STAFF RECOMMENDATION

2004 Linden Avenue

May 21st, 2014

Application: Demolition—principle building and outbuilding; New construction—infill and outbuilding

SITE PLAN

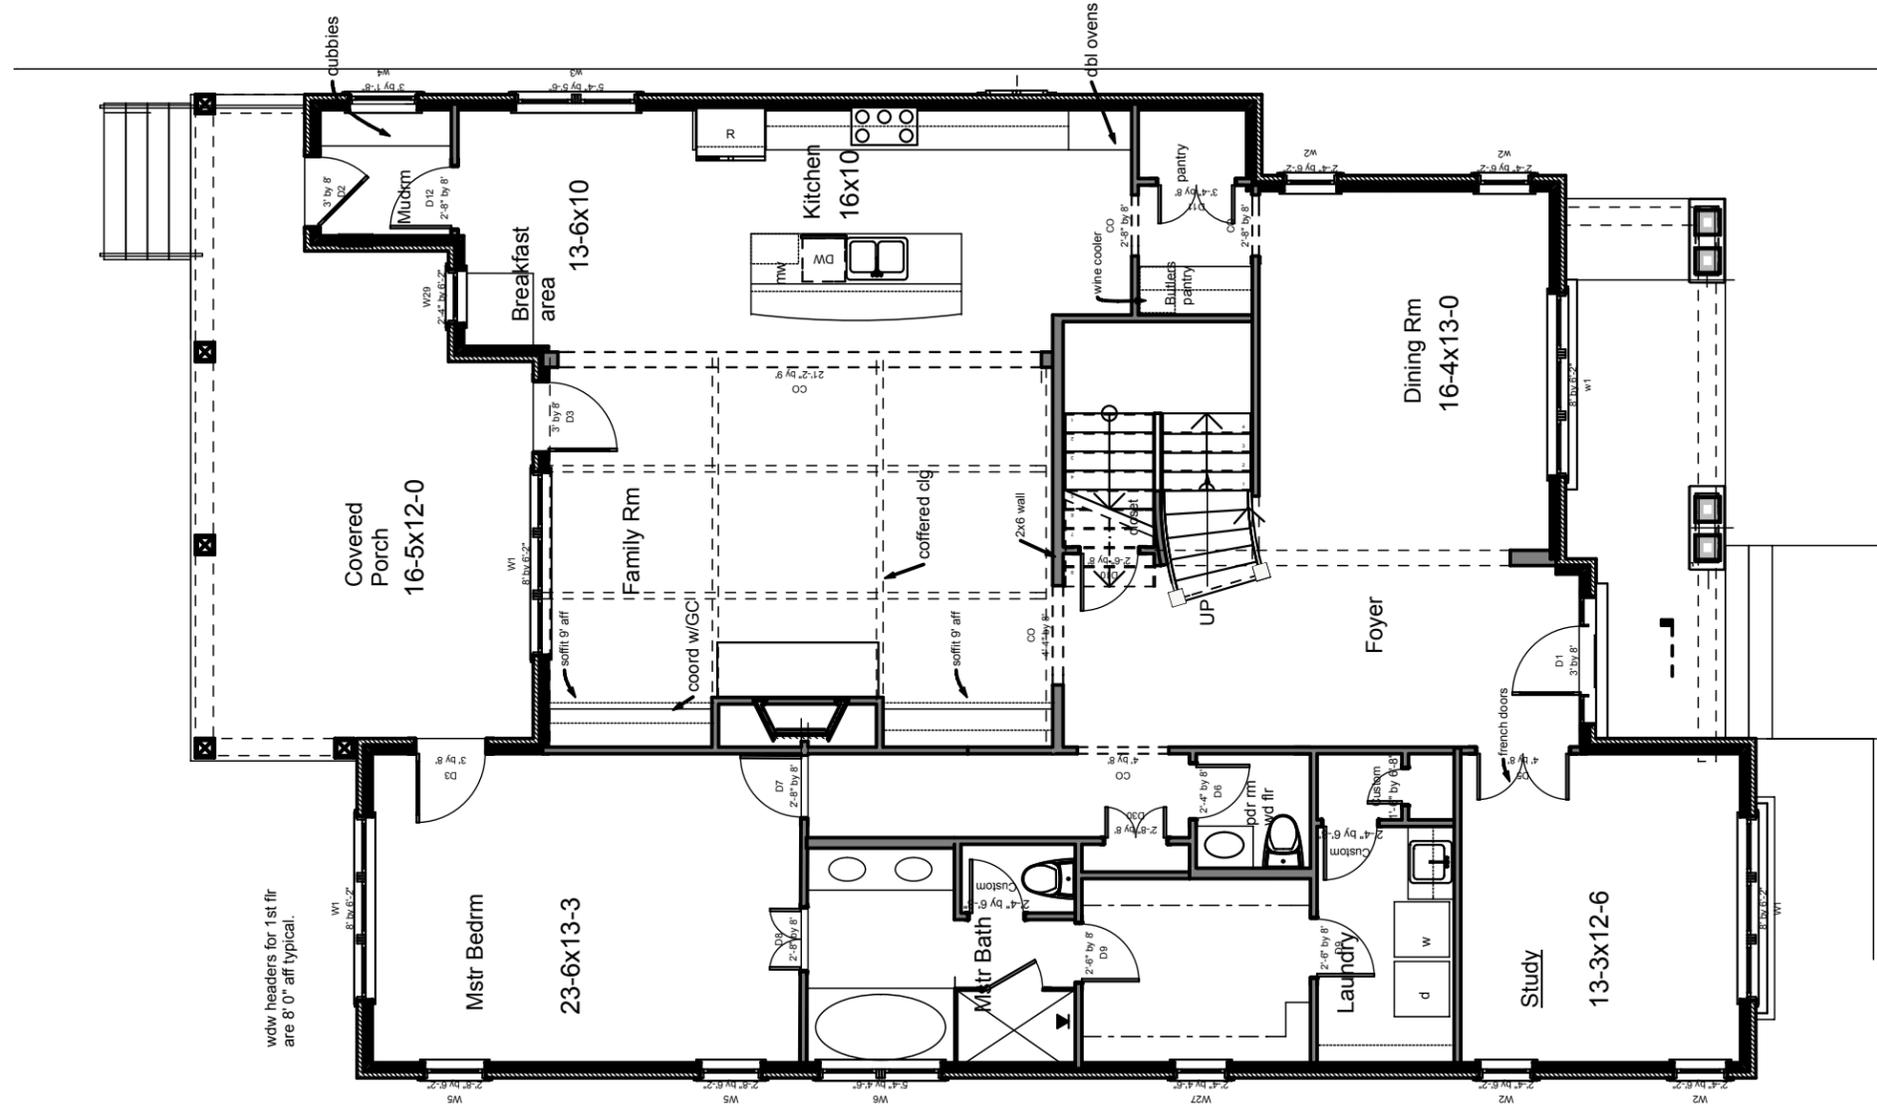
Setback & Rhythm of Spacing: The proposed infill meets all base zoning requirements for setbacks. It is located twelve feet (12') from the east property line to allow for use of a driveway, and it is five feet (5') from the west property line. The infill's protruding bay will be approximately thirty-five feet (35') from the front property line, and the line of the front porch will be thirty-six feet (36') from the front property line. By comparison, the house to the west is set approximately thirty-nine feet, five inches (39'5") from the front property line, and the house to the west is thirty feet (30') from the front property line. The proposed infill's front setback will be approximately the average of the two neighboring properties' setbacks, which is appropriate. Staff finds that the infill's setback and rhythm of space meet section II.B.1.c. of the design guidelines.

Orientation: The proposed infill is oriented to face Linden Avenue. It has a partial-width front porch that is seven feet (7') deep, and a slightly off center front entrance. The mapped alley is not serviceable and currently there is a front-yard parking pad, so the applicant is proposing a new driveway leading from the street to the outbuilding. Staff asks that the driveway be concrete strips to at least the point where the house expands in width. A walkway will lead from the driveway to the porch steps. With the change to the driveway, staff finds that the project's orientation meets section II.B.1.f. of the design guidelines.

1. The foundation height to be no taller than three blocks, or two feet (2') at the front of the house;
2. Staff approve a brick sample, the shingle color, the window and door specifications, and the porch floor material prior to purchase and installation;
3. The driveway be concrete strips to at least the point where the house expands in width;
4. The HVAC be located on the rear façade, or on a side façade beyond the midpoint of the house.

ELEV 1

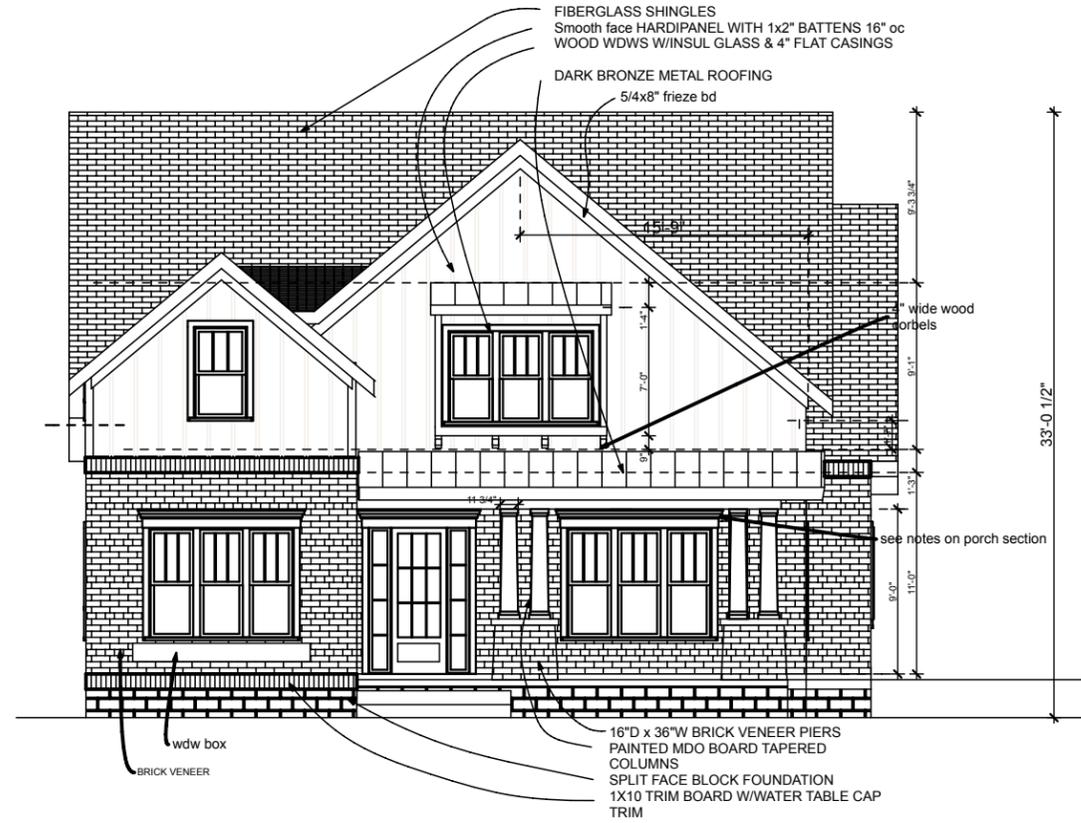
Height & Scale: The proposed infill is one-and-a-half stories tall. It has a foundation height of approximately one foot, six inches (1'6") at the front. The elevation drawings are drawn showing the lot as flat. Recognizing that the lot is not actually flat and portions of the foundation will need to be taller than what is planned for, staff asks that a condition of approval be that the foundation at the front of the house be no taller than three blocks, or two feet (2'). The infill has a porch eave height of approximately twelve feet (12') from grade, an eave height of approximately sixteen feet, six inches from grade (16'6"), and a ridge height of thirty-three feet (33') from grade. Staff finds that the proposed height of the structure matches the historic context, where there are several two-story structures, and the building heights range from twenty-four feet to thirty-five feet (24' – 35') tall.

Materials: The primary cladding material will be brick, and staff asks to approve a brick sample prior to purchase and installation. The house's gable fields will be filled with smooth face Hardie Panel with battens. The foundation will be split face concrete block, and the shingles will be fiberglass. Staff asks to approve the shingle color. The porch roof and front dormer roof will

be a dark bronze metal roofing. The trim will be wood. The porch columns will be wood, but the material of the porch floor was not indicated. Staff asks to approve the porch floor material. The windows will be wood, and staff asks to approve all window and door specifications prior to purchase and installation. With the staff's final approval aforementioned materials and colors, staff finds that the known materials meet Section II.B.1.d of the design guidelines.

Roof form: The proposed infill will have a cross-gabled roof form. The front facing gables will have a pitch of 10/12, while the side gable will have a pitch of 9/12. The front and rear porch roofs will have slopes of 3/12. Staff finds that the proposed roof form and pitches meet the historic context and meet Section II.B.1.e. of the design guidelines.

Proportion and Rhythm of Openings: The windows on the proposed infill are all generally twice as tall as they are wide, thereby meeting the historic proportions of openings. On the front façade, the windows on the ground floor are taller than the windows in the upper story, which is appropriate. There are no large expanses of wall space without a window or door opening. Staff finds the project's proportion and rhythm of openings to meet Section II.B.1.g. of the design guidelines.

GARAGE

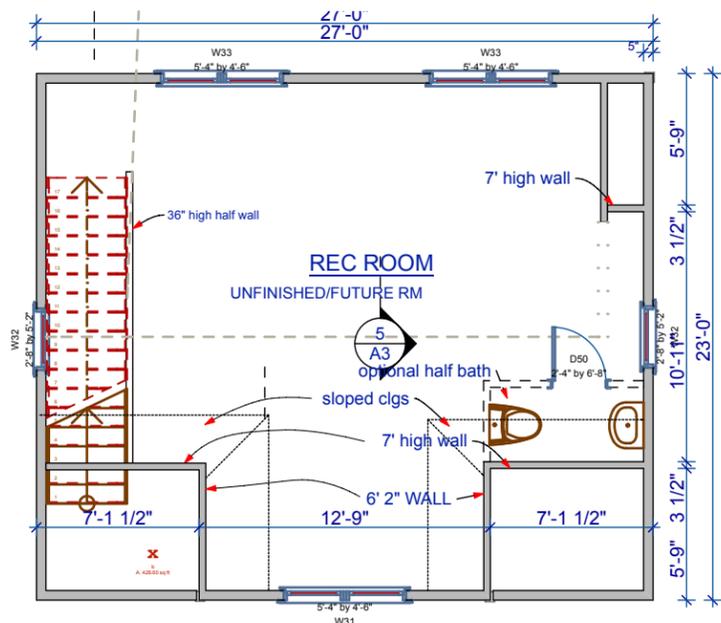
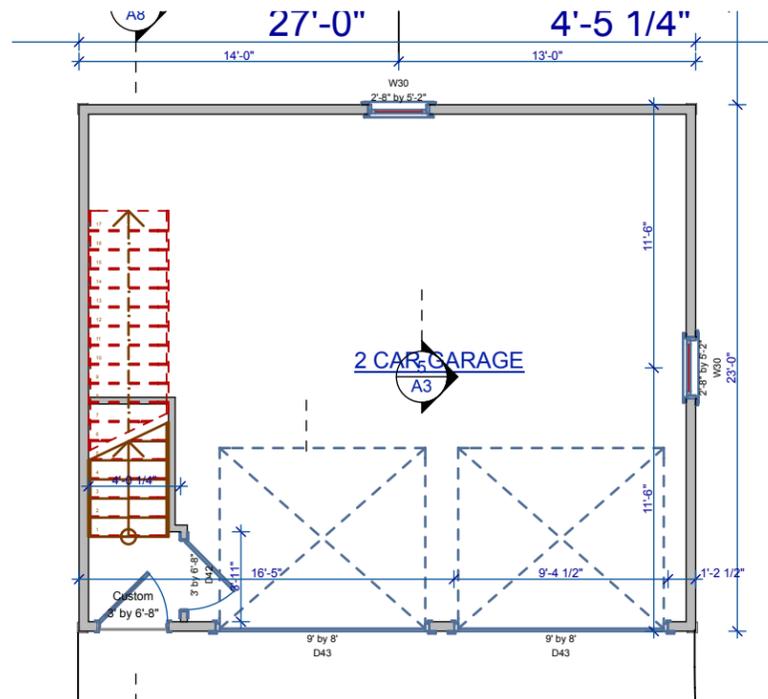
Outbuildings: The applicant is proposing to construct an outbuilding that is twenty-three feet by twenty-seven feet (23' X 27'), or six hundred and twenty-one square feet (621 sq. ft.). The structure will have an eave height of ten feet (10') and a ridge height of twenty-three feet, ten inches (23'10'), which is subordinate to the primary structure. The garage will be accessed via a driveway off of Linden Avenue, which is appropriate since the alley is not serviceable behind this property. There will be two separate garage doors facing the street, and the proportion and rhythm of openings for the garage are appropriate for an outbuilding. The outbuilding meets all base zoning setbacks. It will be more than ten feet (10') from the rear property line, and over four feet (4') from the east property line. The materials for the structure will be similar to those for the infill. The primary cladding material will be Hardie Panel boards with battens, the foundation will be a concrete slab, the roof will be fiberglass shingles, and the windows and doors will be wood. The roof will be a side gable with a slope of 12/12. A gabled dormer with a slope of 12/12 will be on the garage's front façade, while a shed dormer with a slope of 4/12 will be on the garage's rear façade. Staff finds that the proposed outbuilding meets Section II.B.1.i of the design guidelines.
